## **RESPONSE TO SUBMISSIONS - EASTLAKES SHOPPING CENTRE MOD 1**

This letter has been prepared by Urbis on behalf of Stateland East Unit Trust (The Applicant) regarding MP09\_0146 Mod 1 – Modification to Eastlakes Shopping Centre Mixed Use Development. The Modification was placed on public exhibition from 8 August – 23 August 2017 and submissions were received from the community, local and state agencies.

Figure 1 – Approved Pylon Sign

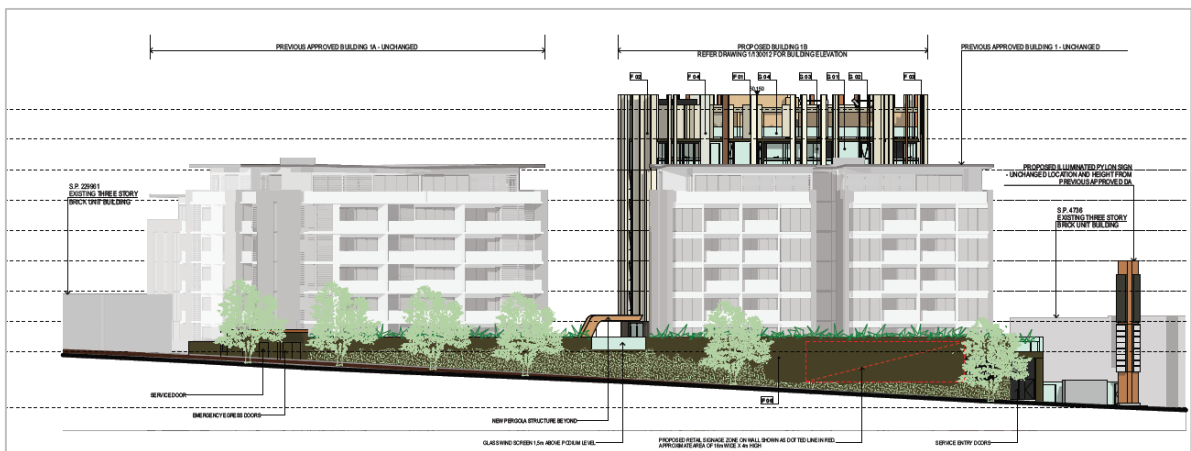
- Minor amendments to the approved pylon sign in the north-western corner of the site fronting Gardeners Road. The approved height and location of the sign remains unchanged.
- Provision of a 16m (w) x 4m (h) signage zone at podium level fronting Gardeners Road.

The podium signage zone to Gardeners Road formed part of the MP09\_0146 application. Condition B2(f) – Design Modification of the Project Approval required it to be moved further west along Gardeners Road above the sub-station opening. The sign was subsequently deleted from the plans and did not form part of the Architectural Drawings approved under the discharge of Condition B2.

It is now sought to reinstate the signage zone along Gardeners Road. It is considered that Gardeners Road is a suitable location for signage and the proposed amendments sought by this modification to landscaping along this frontage enables it to be visible from the roadway.

A comparison between the approved and proposed signs is illustrated in the Figures below.
